ENDL TEXAS

Date: 20 February 2006
 To: T10 Technical Committee
 From: Ralph O. Weber
 Subject: SAS-2 Zoning sans Management

Figure n2 — ~~Figure 45—Zone~~ Zoning expander route table example

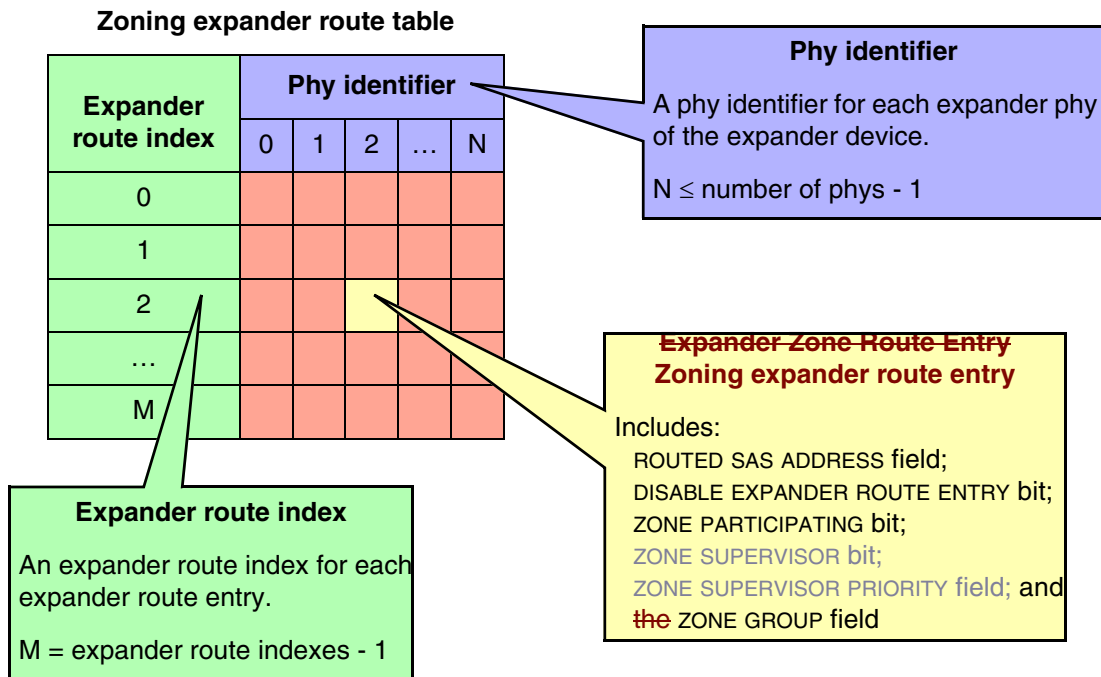
ROW Note 3: The text marked for deletion below duplicates a requirement that is stated in 4.9.2.

~~Zoning expander devices shall be self-configuring.~~ The zone route table of in a zoning expander device shall contain zone phy information in addition to the expander phy information.

Figure 2 shows a representation of a zoning expander ~~zone~~ route table.
